Update on the Remedial Design for Parcel E-2

**Hunters Point Naval Shipyard
BCT Meeting**

January 23, 2014

Design Basis Report Figure 18 – Future Wetlands

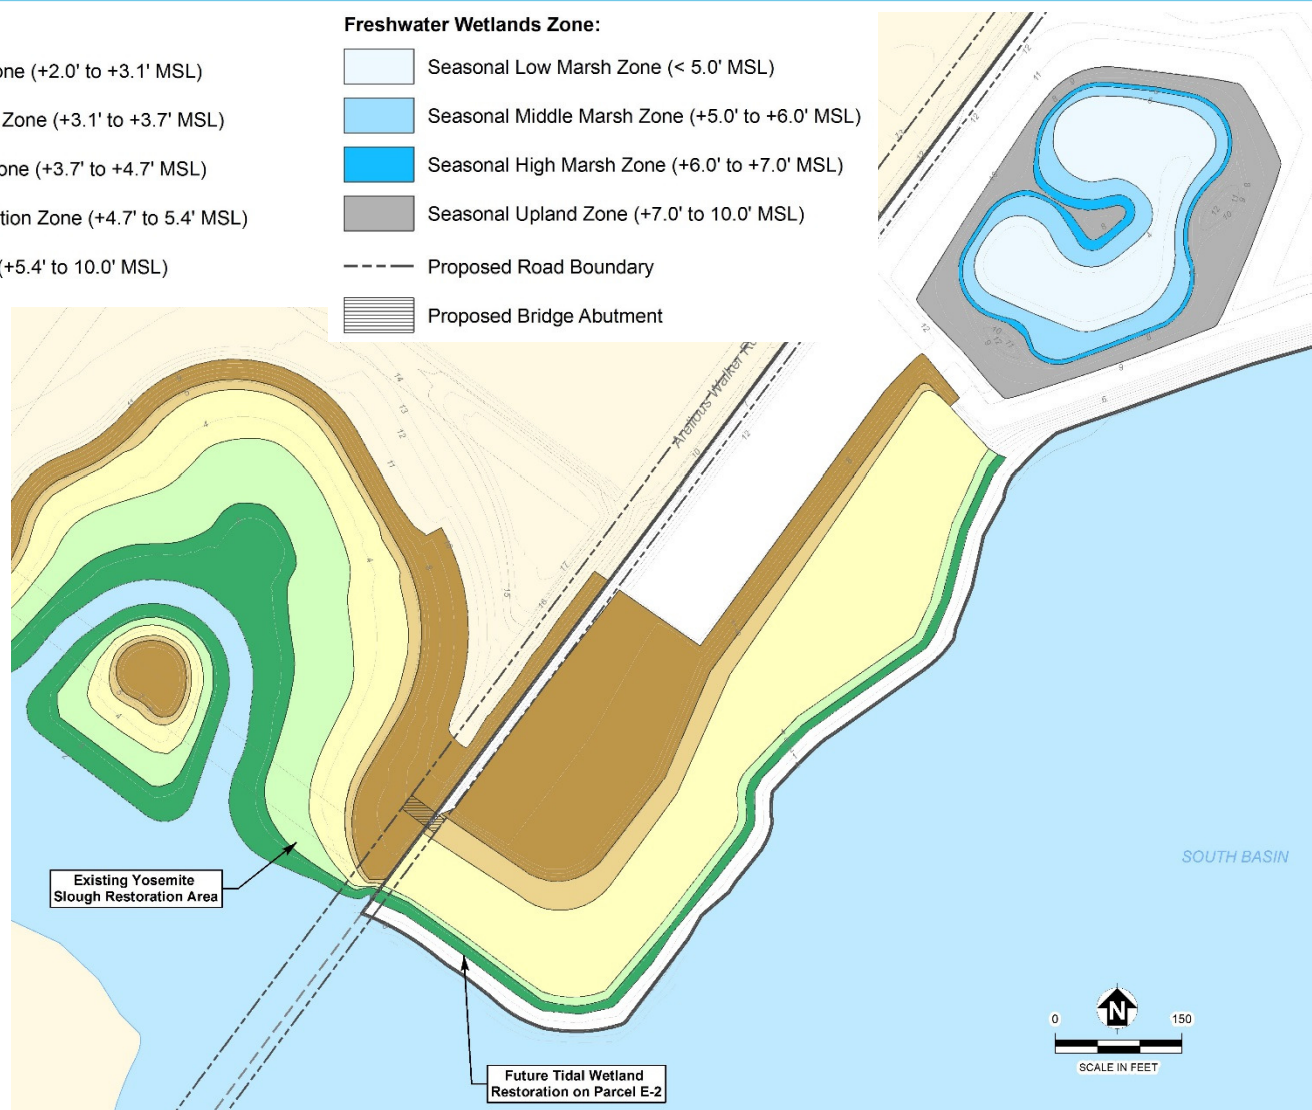
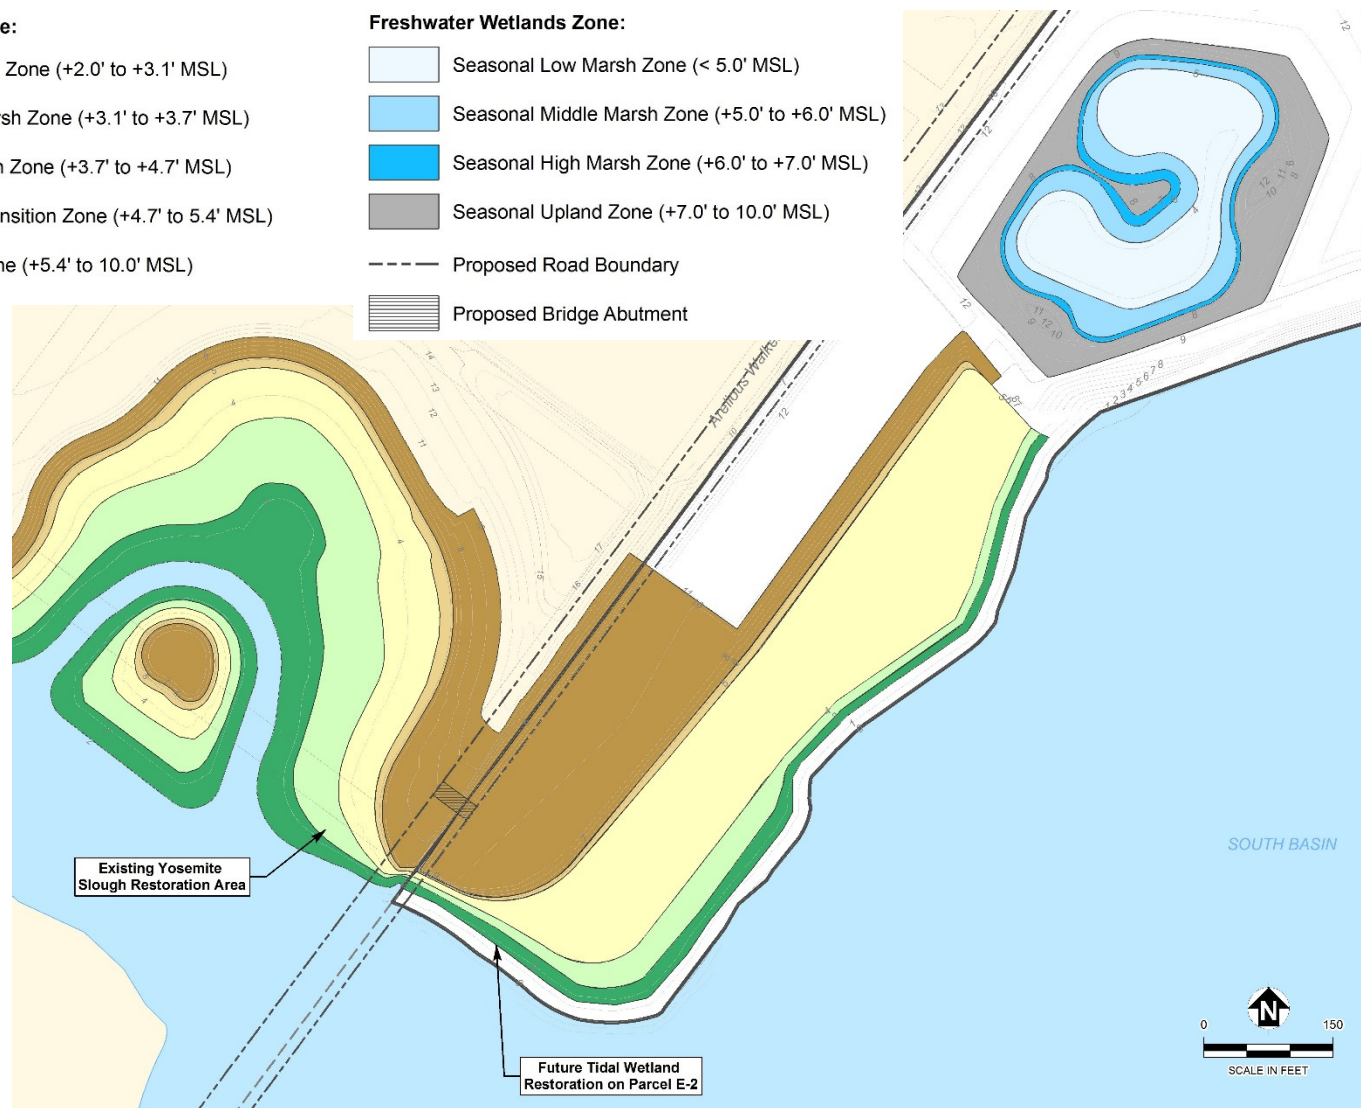
- **A future bike path is required to be placed under the Arelious Walker bridge**
 - This is a requirement of the settlement agreement for the lawsuit regarding the bridge construction
- **The future bike path prompted the construction of an elevated plateau on the Yosemite Slough property**
 - The elevated plateau is not continuous with the topography of the tidal wetlands at Parcel E-2
- **The Navy proposes to modify the topography of the tidal wetlands on Parcel E-2 to integrate with the topography of the Yosemite Slough property**

Remedial Action Monitoring Plan Figure 6 – Stormwater Monitoring Locations

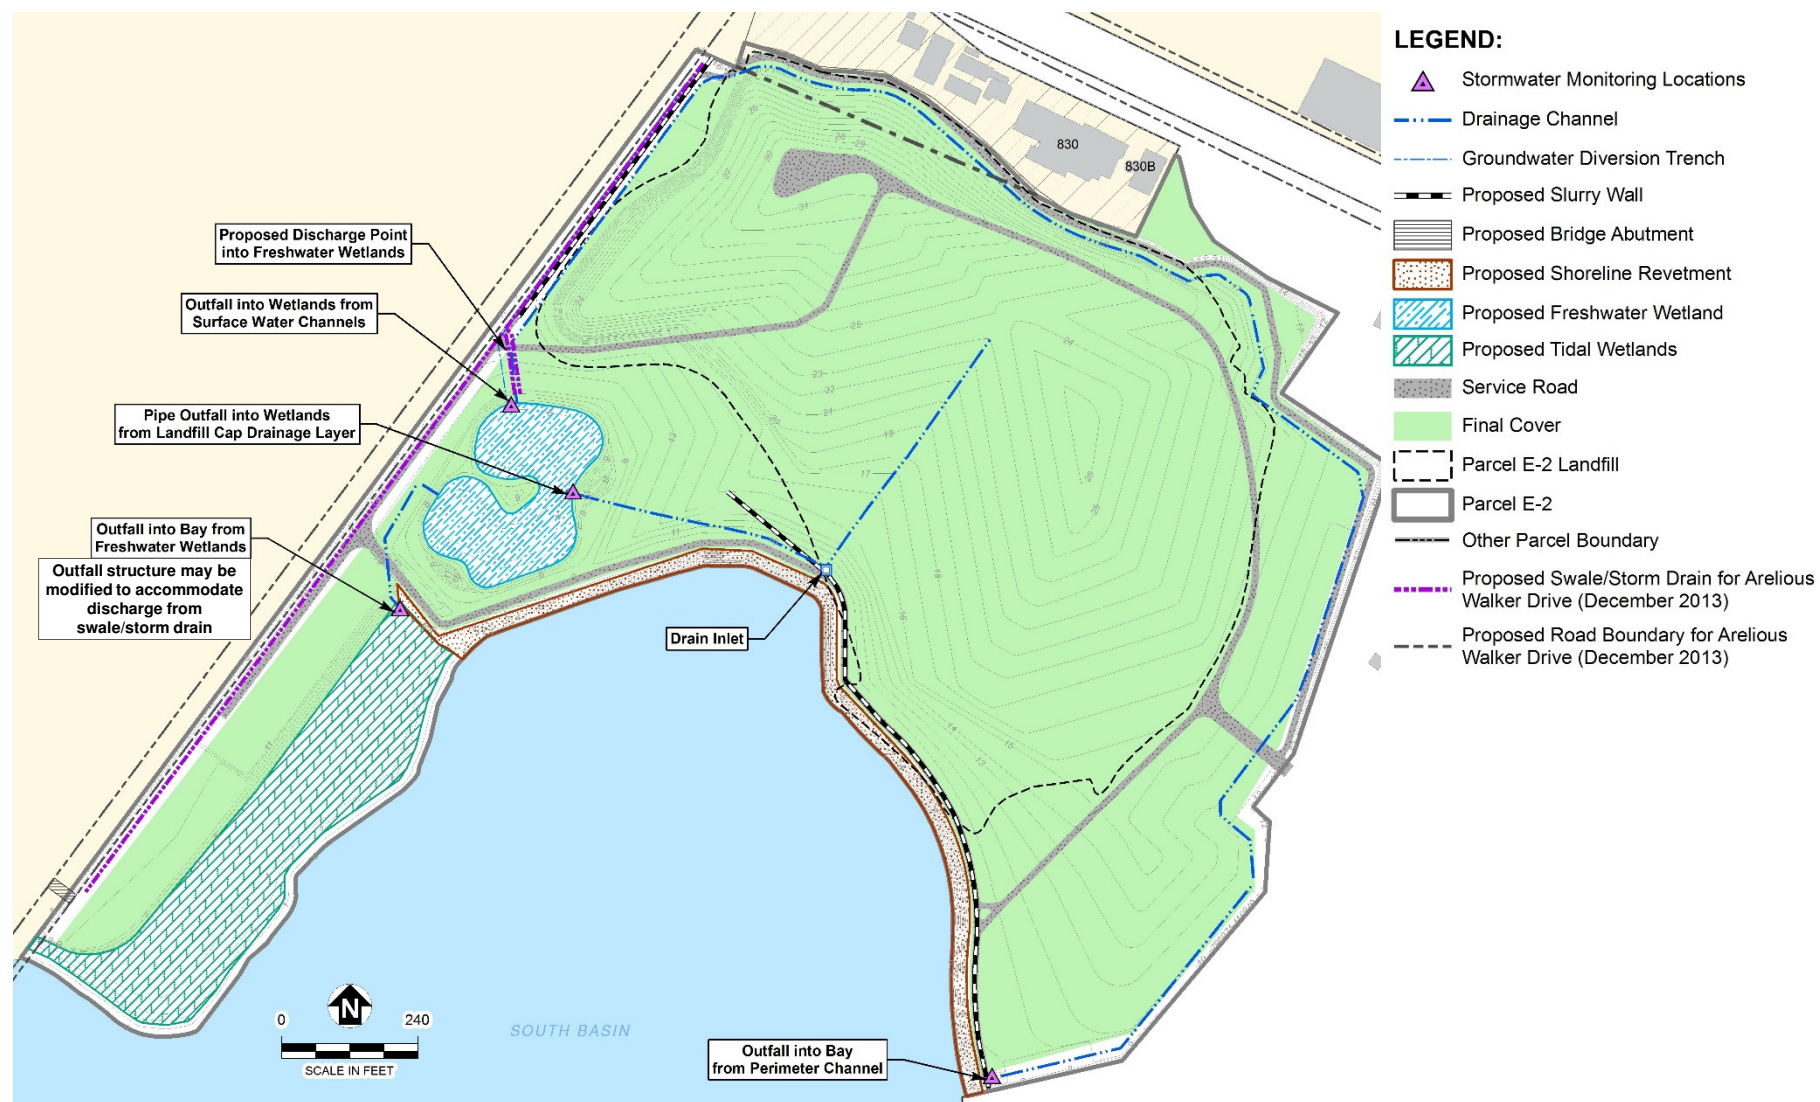
- **A stormwater swale and drain are proposed to convey surface water runoff from the new roadway to the bay**
 - The vegetated swale will provide treatment before surface water runoff flows into the underlying storm drain
 - The storm drain is proposed to discharge into the Navy's freshwater wetland, but the developer can revise the design to discharge into the tidal wetland
- **The Navy prefers that the City's storm drain discharge into the tidal wetlands because combining onsite and offsite surface water discharge within the freshwater wetland would complicate future compliance monitoring and responses**
- **The Navy's outfall structure will be refined to include a separate discharge pipe for the City's storm drain (which will require separate monitoring)**
